Access Compliance Report

Public Rights-of-Way

(Curb Ramps)

Intersection ID: 12770	Main Street: HICKORY GROVE RD	Cross Street: N_SHARON AMITY RD	Location: NE
ADA ID: D1CD1D615773	Ramp Type: Perp	Initial Pass/Fail: Fail	Overall Compliance: No
Severity Score: 22.5			
Codes/Mitigation Info/Possible Solution		Field Measurements/Component Compliance

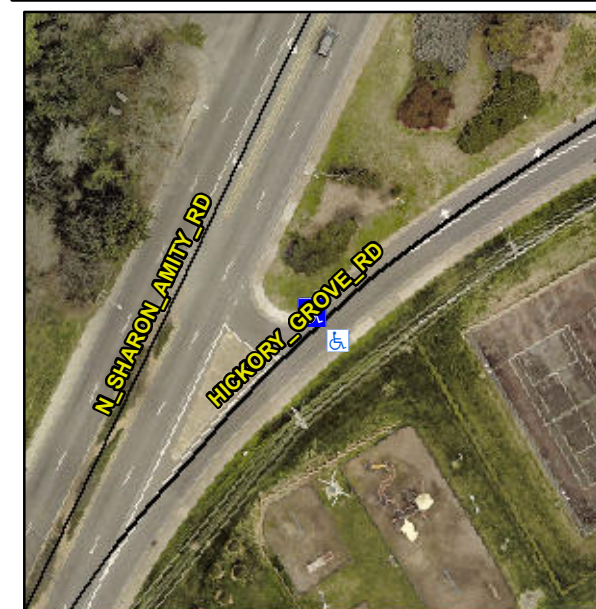
Not Found, R304.5.1, R304.2.2

Compliance	Description	Data	Compliance	Description	Data
N/A	Ramp Length (in)	61.0	No	Ramp Slope (%)	9.3
No	Ramp Width (in)	47.0	Yes	Ramp XSlope (%)	3.0
N/A	Flare Type LT	N/A	N/A	Flare Type RT	N/A
N/A	Flare Slope LT (%)	N/A	N/A	Flare Slope RT (%)	N/A
N/A	Flare Traversable LT?	N/A	N/A	Flare Traversable RT?	N/A
N/A	Landing Length (in)	N/A	N/A	DWS Provided?	N/A
N/A	Landing Width (in)	N/A	N/A	DWS Contrast?	N/A
N/A	Landing Slope (%)	N/A	N/A	DWS Length (in)	N/A
N/A	Landing X Slope (%)	N/A	N/A	DWS Full Width?	N/A
N/A	Landing Curb? (Y/N)	N/A	N/A	DWS Offset (in)	N/A
N/A	Shared Landing?	N/A			
N/A	Gutter Ponding?	N/A	N/A	Gutter Slope (%)	N/A
N/A	Gutter Lip Ht (in)	N/A	N/A	Gutter X Slope (%)	N/A
N/A	Painted X Walk1?	No	N/A	Painted X Walk2?	N/A
	X Walk 1 Direction	To S		X Walk 2 Direction	N/A
N/A	X Walk 1 Width (in)	N/A	N/A	X Walk 2 Width (in)	N/A
	X Walk 1 Slope (%)	3.0		X Walk 2 Slope (%)	N/A
	X Walk 1 X Slope (%)	3.3		X Walk 2 X Slope (%)	N/A

Remove & Replace Entire Ramp.
